**Airspace Change Proposal
Stage 2a**

**London Southend Airport Design
Principle Evaluation - Annex**

London Southend Airport FASI(S)

ACP-2018-90

Figure 1: Departure Options Runway 05 - Northeast

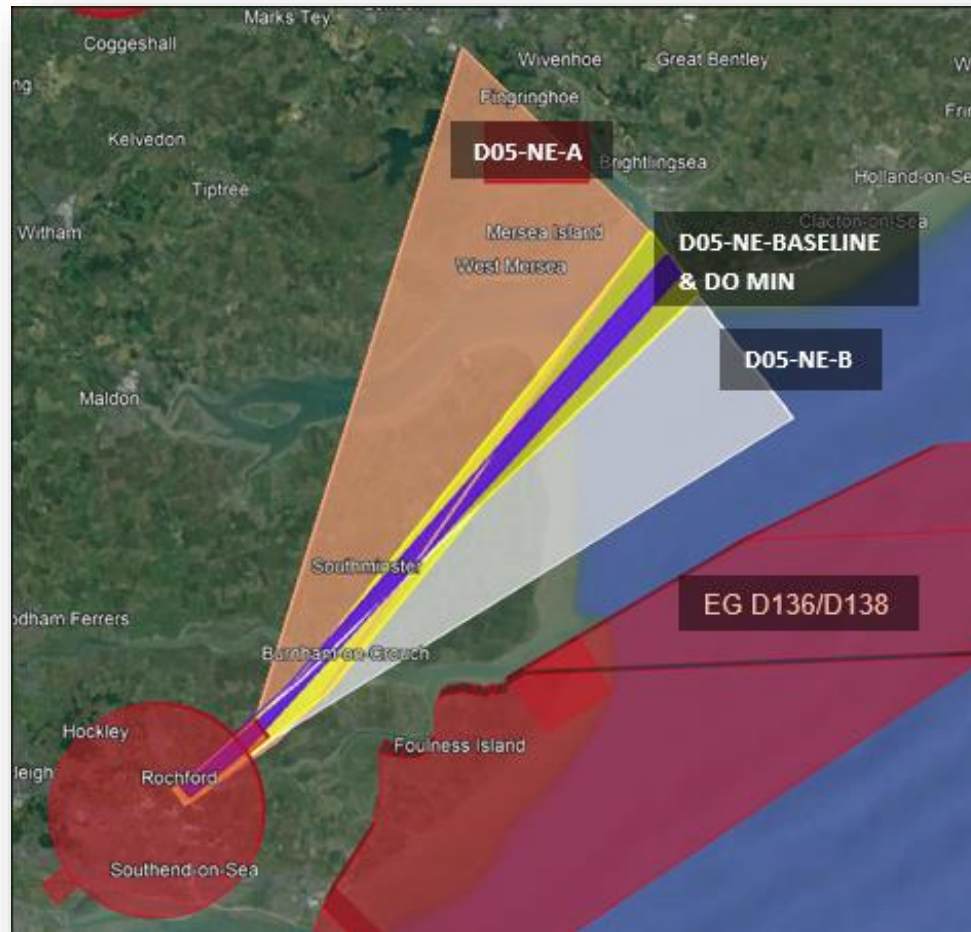
DP3 – Noise Footprint – Similarly to the comment highlighted above, ECC recommends that the qualitative assessment provides an understanding as to the communities that would continue to be impacted by the adoption of this flight path option.

DP4 – Tranquillity – ECC notes that DP4 now includes reference to ‘education’ as outlined on page 13 of the consultation document. However it is acknowledged that throughout the assessment there is no reference to education or any community and social infrastructure that may be sensitive to noise. ECC’s response dated 5th May 2022 demonstrated that sensitive receptors may include schools, Early Years and Child Care Facilities, facilities for Special Educational Needs, and Residential Care Homes. It should be noted that the noise threshold to avoid a breach on school sites is 55db LAeq (30min). It is unclear from reviewing the assessment as to whether these noise sensitive receptors have been considered and any impacts noted.

‘DP10: NERL would comment that simply making a SID RNAV would not necessarily equate to free flow on that route.’

NE – A and B – The table provides an amber RAG rating for DP 4 – Tranquillity. It would appear that the A and B routes have been scored because of conflict with a sensitive area. The map and any information outlined in the booklet gives very little detail on the precise nature of the sensitive areas that are analysed beyond the Shoeburyness Danger Area. ECC considers that there are sites that may be considered sensitive areas (e.g. environmentally sensitive, noise sensitive schools, independent living accommodation etc), and these should be clearly identified and understood. Furthermore, the table should provide a brief overview to justify the rating, so that all partners are aware of why a specific rating has been applied. This will assist future review and ensure that the process is clear, logical and transparent for partners.

DP10 – Systemisation - Similarly to the comments set out above the table scores this as amber with ‘possible conflict’ as the justification. In reviewing this table, it is recommended if the justification could provide a clear understanding of the conflict or systemisation issues that may arise, so that all partners are aware.

DP2- We have added the key areas overflown in today’s operation. We have not changed the wording of the assessment as with this option there would be no change from what happens today so there would be no change to the number of people overflown. DP3/DP11 – These communities have been listed in DP2. DP4-Whilst the DP lists sites of care or education, they have not been included at this stage due to the ‘swathe approach’ covering too large an area to be useful when assessing individual sites– these will be fully assessed later in the options appraisal stages when the swathes are refined to more precise routes - ‘lines on the map’. DP9- The DP has been deemed not to meet the technical requirements DP, if we were to make amendments as suggested that would then make this BASELINE option the DO-MIN option, as the DO-MIN is a refinement of the BASELINE utilising modern technology.

Following the response to the survey from Gatwick Airport, LSA spoke with them and explained how departures are currently handled. It was explained that the Preferential Departure Routes (PDRs) are subject to tactical release in addition to release by the LSA radar Air Traffic Control Officer (ATCO). The procedure was discussed in detail, and it was explained that for some departures a release from TC South and Thames is required, these are en-route sectors², furthermore this requires 3 coordination calls³, when the aircraft is ready at the runway holding point. This process can regularly result in delays, and given LSA’s limited taxiway infrastructure, the delay becomes cumulative to the other aircraft in the departure sequence. With the introduction of an RNAV SID, which integrates with the enroute network, the aim is to reduce the coordination currently required and potentially facilitate free flow⁴ for the departures.⁵

DP2- we have added the key areas overflown in today's operation. DP3/DP11 – These communities have been listed in DP2. DP4-Whilst the DP lists sites of care or education, they have not been included at this stage due to the 'swathe approach' covering too large an area to be useful when assessing individual sites– these will be fully assessed later in the options appraisal stages when the swathes are refined to more precise routes - 'lines on the map'. DP9- The DP has been deemed not to meet the technical requirements DP, if we were to make amendments as suggested that would then make this BASELINE option the DO-MIN option, as the DO-MIN is a refinement of the BASELINE utilising modern technology.

Figure 2: Departure Options Runway 05 - Northwest

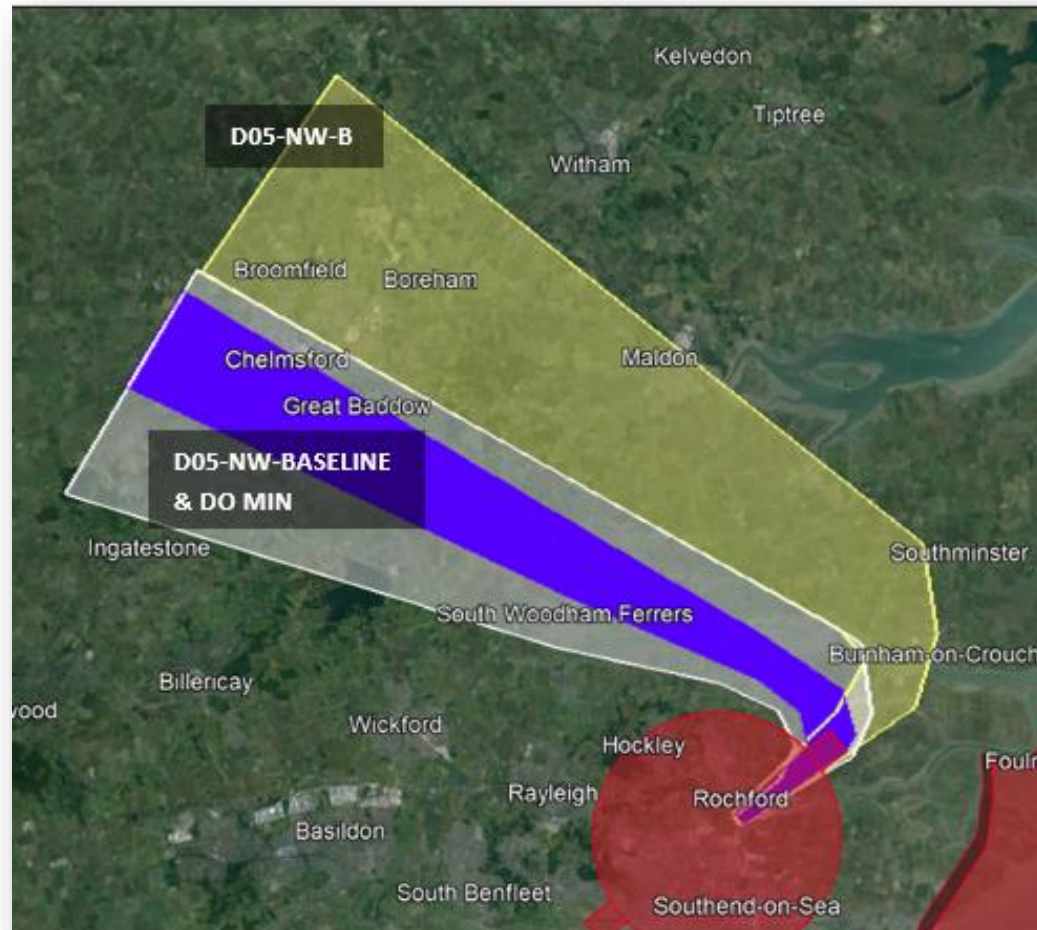
ECC notes that DP2 entitled overflight states that “the New Procedures should not increase the number of people overflown by aircraft using the Airport and where possible options that provide a level of dispersion should also be considered”. The analysis of the impact for runway 05 – North-West highlights NW-B as amber due to “different communities, possibly at lower level”. ECC questions the application of DP2, as this justification does not demonstrate whether there has been increase in persons overflown, which is the purpose of the DP2. From the brief justification text, it is considered that the weight to legacy routes is something that is being assessed within DP2, which is not the purpose of DP2. ECC does consider that within the analysis due consideration should be given to legacy routes, and therefore following this exercise a review of the precise wording for the Design Principles may be required prior to advancing to the next stage in the CAP1616 process.

NW-A scores DP4 as amber while DP4 (tranquillity) for NW-B is fully met. ECC considers that the information presented does not clearly allow for an appreciation of the impact on sensitive areas. Our overarching response highlights some of the sensitive areas that should be considered when reviewing the impact of airspace route changes, and it is welcomed that the justification demonstrates a review of such information and then appropriate RAG score given with a supporting justification.

Response to question 7 – '4 - Tranquillity: it is understood that sites of cultural heritage value are also identified as being noise sensitive areas and therefore Rayleigh Mount (5.5km north west of London Southend Airport) which is a Scheduled Ancient Monument (SAM) should be assessed in respect of frequency of overflights at this location.'

'Please provide further detail on how the systemisation DP has been met.'

DP2- we have added the key areas overflown in today’s operation. DP3 – These communities have been listed in DP2. DP4-Whilst the DP lists sites of care or education, they have not been included at this stage due to the ‘swathe approach’ covering too large an area to be useful when assessing individual sites– these will be fully assessed later in the options appraisal stages when the swathes are refined to more precise routes - ‘lines on the map’. DP5 – This is our BASELINE option – today’s operation, so Emissions and Air Quality is Amber by definition “CO2 emissions likely to be the same or similar to today’s operation.”

Following the response to the survey from Gatwick Airport, LSA spoke with them and explained how departures are currently handled. It was explained that the Preferential Departure Routes (PDRs) are subject to tactical release in addition to release by the LSA radar Air Traffic Control Officer (ATCO). The procedure was discussed in detail, and it was explained that for some departures a release from TC South and Thames is required, these are en-route sectors⁶, furthermore this requires 3 coordination calls⁷, when the aircraft is ready at the runway holding point. This process can regularly result in delays, and given LSA's limited taxiway infrastructure, the delay becomes cumulative to the other aircraft in the departure sequence. With the introduction of an RNAV SID, which integrates with the enroute network, the aim is to reduce the coordination currently required and potentially facilitate free flow⁸ for the departures⁹.

Figure 3: Departure Options Runway 05 - South/ Southeast

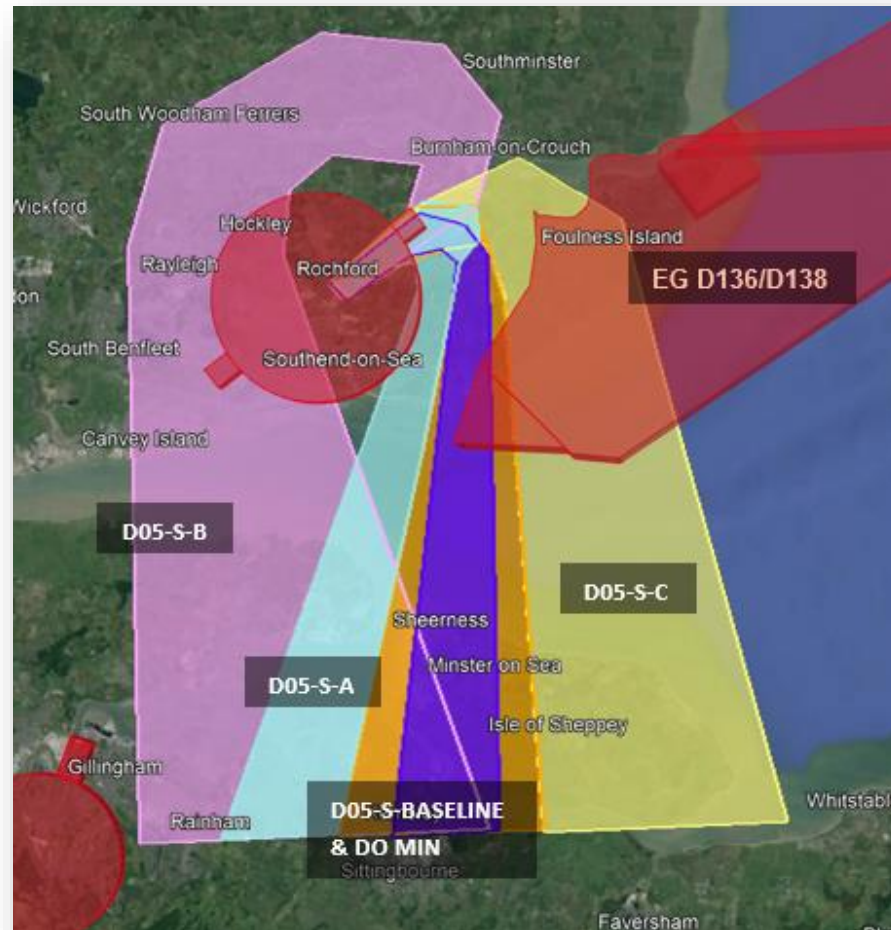
Response to question 7 – '4 - Tranquillity: it is understood that sites of cultural heritage value are also identified as being noise sensitive areas and therefore Rayleigh Mount (5.5km north west of London Southend Airport) which is a Scheduled Ancient Monument (SAM) should be assessed in respect of frequency of overflights at this location.'

'05 S B used to be the only departure procedure for runway 05, which was replaced by 05 S A few years ago with aircraft departing 05 and flying over the villages of Stonebridge, Little and Great Wakering Barling Shoeburyness in the climb but restricted on altitude by London ATC both S A and S B should be replaced by S C avoids flying over the population and wildlife areas therefore making the departures safer, but would involve coordination with the military DA authorities, as there will be scheduled services using this route pre planning of their activities wouldn't be an issue avoiding the departure times of aircraft.'

ECC notes that for Runway 05 – South/South-East there are three possible options S- A, S-B and S-C. It is appreciated that there are a few Design Principles DP4, DP5, DP6, DP10, DP11 and DP13 that for some or all airspace route options have been scored amber and in one case red. In reviewing the information that is set out ECC questions whether the assessment has been consistent in the application of whether the benefits of continuous climb and the aircraft reaching its cruising altitude quicker have been consistently applied. ECC acknowledges that where an aircraft can operate continuous climb procedures and reach a cruise altitude quicker the flight can reach the most fuel-efficient conditions. It would therefore be appreciated if the analysis could provide some justification as to whether additional track miles may/may not facilitate the ability for the aircraft to engage in continuous climb and possibly reduce a stepped climb which would increase fuel usage. Furthermore ECC questions whether there may be options for using alternate routes for this option and facilitate respite options for the local communities.

DP2- we have added the key areas overflown in today's operation. DP3/DP11 – These communities have been listed in DP2. DP4-Whilst the DP lists sites of care or education, they have not been included at this stage due to the 'swathe approach' covering too large an area to be useful when assessing individual sites– these will be fully assessed later in the options appraisal stages when the swathes are refined to more precise routes - 'lines on the map'.

LSA have provided textual justification across all of the DPs, especially when the RAG score has changed, specifically DP11 relates to this feedback. Additionally, since the engagement we have developed standardised evaluation criteria to ensure consistency across all of the DPs and Options. This can be found in Annex E of the document titled ‘ACP Options Development and Design Principle Evaluation’ and can be found on the ACP Portal.

Figure 4: Departure Options Runway 23 - Northeast

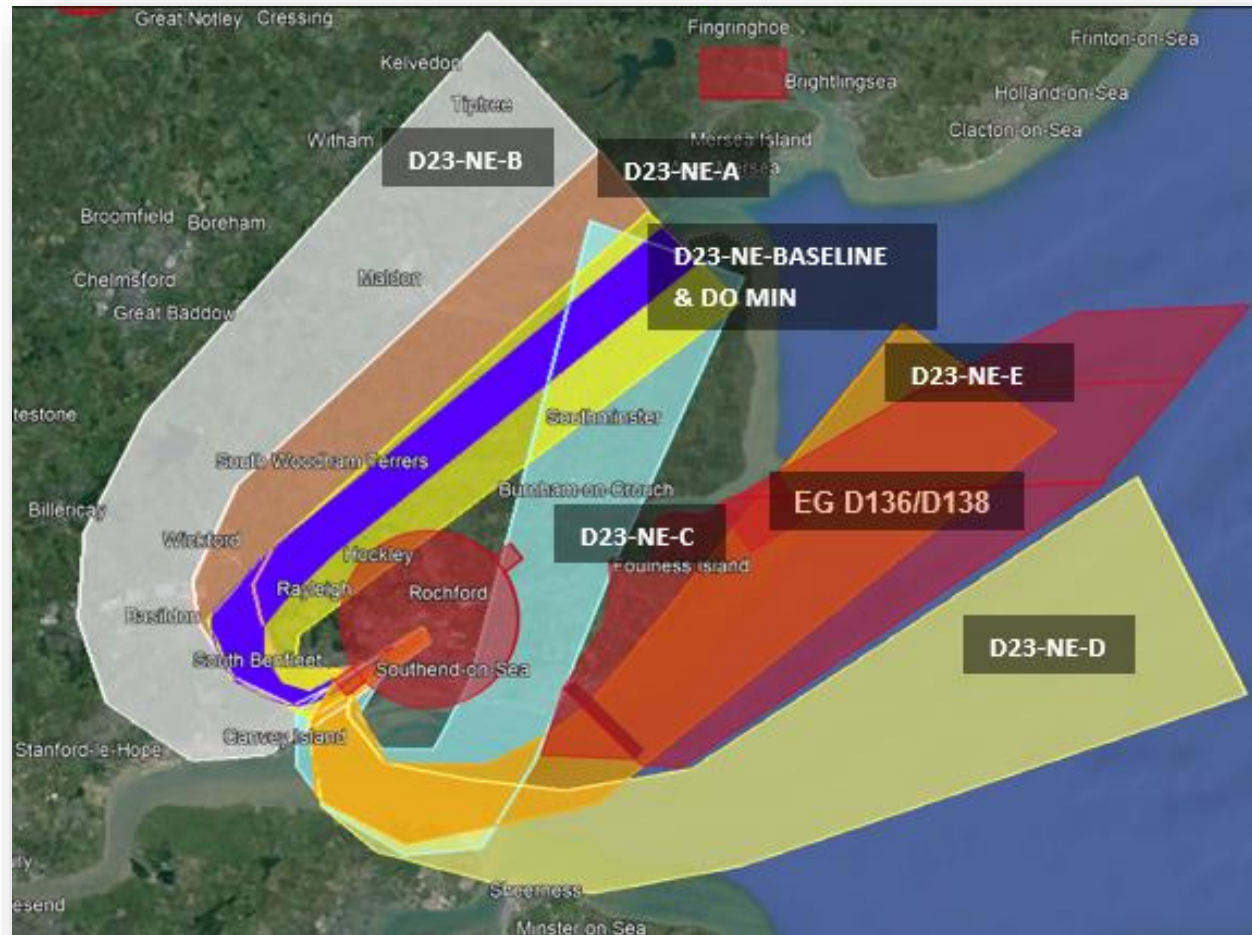
‘No; Departures 23 Northeast D23 NE A DP2 Over flight DP3 Noise DP4 Tranquillity procedure to be re written to ensure the aircraft are 1,000’ higher at the point before they turn and change acceleration altitude to 4000.’

ECC notes that for NE-B, DP2 (Overflight) is scored as amber and it states in the text ‘potential increase in overflight of Canvey Island and Basildon (at a higher level)’, it also states for DP13 (PBN) that it is amber due to ‘increased potential for step climb’. ECC questions whether the ability to achieve a higher altitude would not allow for continuous climb, and the reason for traffic being held down. It is assumed that this is due to

ECC notes that NE-C is scored amber for DP7 (airspace dimensions) due to conflict with the IFP Danger Area, ECC considers that there may still be operational used for this route as it may provide respite opportunities.

‘No; Departures’ 23 Northeast D23-NE- B DP2 Over flight DP3 Noise DP 4 Tranquillity procedure to be re written to ensure the aircraft are 1,000’ higher at the point before they turn and change acceleration altitude to 4000’ ensure the aircraft climb straight ahead to 4000’ or 3 nm before turning right then between Canvey Island and South Benfleet then North bound when passing 5000’ or bowers Gifford follow the A130 northbound.’

Criteria 8 Airspace Complexity - I note the explanatory qualitative assessment, but the outcome remains fully met. This is inconsistent with the criteria 7 and the interaction with the Shoeburyness Danger Area. The Assessment needs to evaluate in a consistent and logical manner. Criteria 7 and 8 should be consistent in their assessment.

DP2- we have added the key areas overflown in today's operation. DP3 – These communities have been listed in DP2. DP4-Whilst the DP lists sites of care or education, they have not been included at this stage due to the 'swathe approach' covering too large an area to be useful when assessing individual sites– these will be fully assessed later in the options appraisal stages when the swathes are refined to more precise routes - 'lines on the map'. DP10 – London Stansted Airport listed.

LSA have amended the description and RAG score of DP4 to reflect Southend City Council's comments. For DP2 - Overflight, which is assessed as fully met, the Evaluation Criteria states 'No different than today or less people overflown' which is correct when related to the baseline so the original assessment stands.
